H. B. ROBINSON STEAM ELECTRIC PLANT, UNIT NO. 2

**RESPONSE TO REQUEST FOR ADDITIONAL INFORMATION REGARDING
SEISMIC QUALIFICATION OF MECHANICAL AND ELECTRICAL EQUIPMENT**

H. B. ROBINSON STEAM ELECTRIC PLANT, UNIT NO. 2
REQUEST FOR ADDITIONAL INFORMATION
REGARDING VERIFICATION OF SEISMIC ADEQUACY OF MECHANICAL
AND ELECTRICAL EQUIPMENT IN OPERATING REACTORS

Figure 7A-2: H.B. ROBINSON; REACTOR AUXILIARY BLDG
Comparison of Licensing Basis Spectra vs SQUG Bounding Spectrum

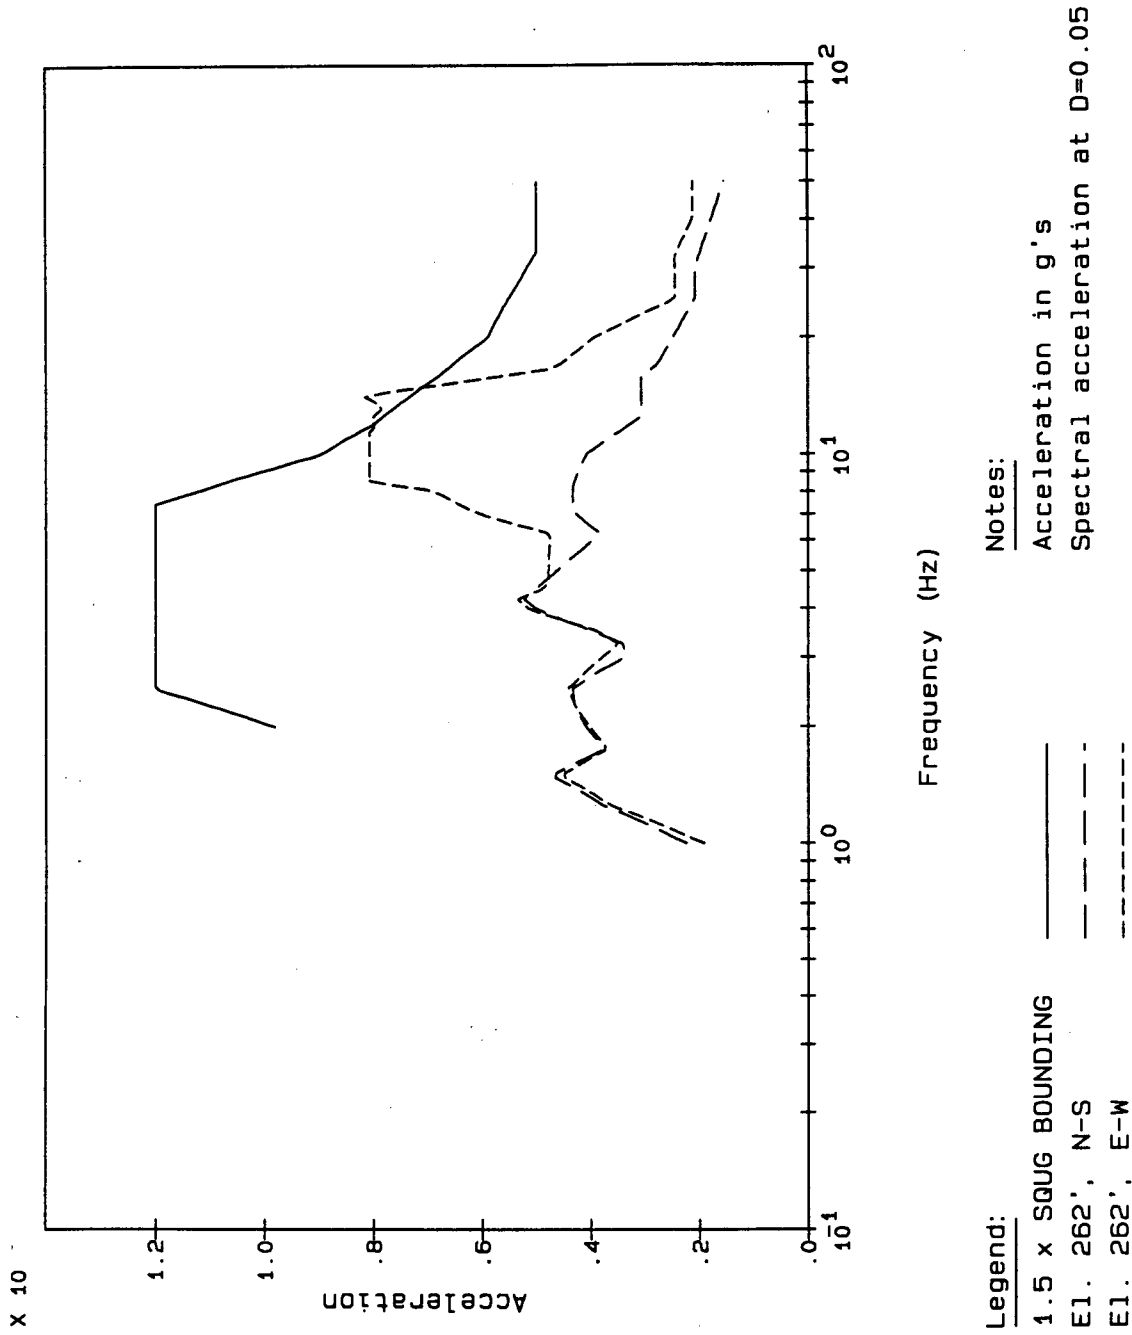
Identify structure(s) that have in-structure response spectra (5 percent critical damping) for elevations within 40 feet above the effective grade that are higher in amplitude than 1.5 times the SQUG Bounding Spectrum.

For the structure(s) identified in Item (a) above, provide the in-structure response spectra designated according to the height above the effective grade. If the in-structure response spectra identified in the 120-day response to Supplement No. 1 to GL 87-02 were not used, provide the response spectra that were actually used to verify the seismic adequacy of equipment within the structures identified in Item (a) above. Also, provide a comparison of these spectra to 1.5 times the Bounding Spectrum.

Five percent damped in-structure spectra for the following two floor elevations exceeds the Reference Spectrum (1.5 times the SQUG Bounding Spectrum) and are considered less than about 40 feet above effective grade.

- Reactor Auxiliary Building - Elevation 262'
- Turbine Building - Mezzanine Elevation

In-structure response spectra as discussed in the 120-day response to Supplement No. 1 to GL 87-02 were used in the A-46 walkdowns and evaluations. Response spectra addressed in Question 3a above are included as Enclosure 2 to this Attachment. Height above grade is included below.

<u>Building - Floor Elevation</u>	<u>Height Above Grade</u>
Reactor Auxiliary Building - Elevation 262'	36 feet
Turbine Building - Mezzanine Elevation	16.5 feet
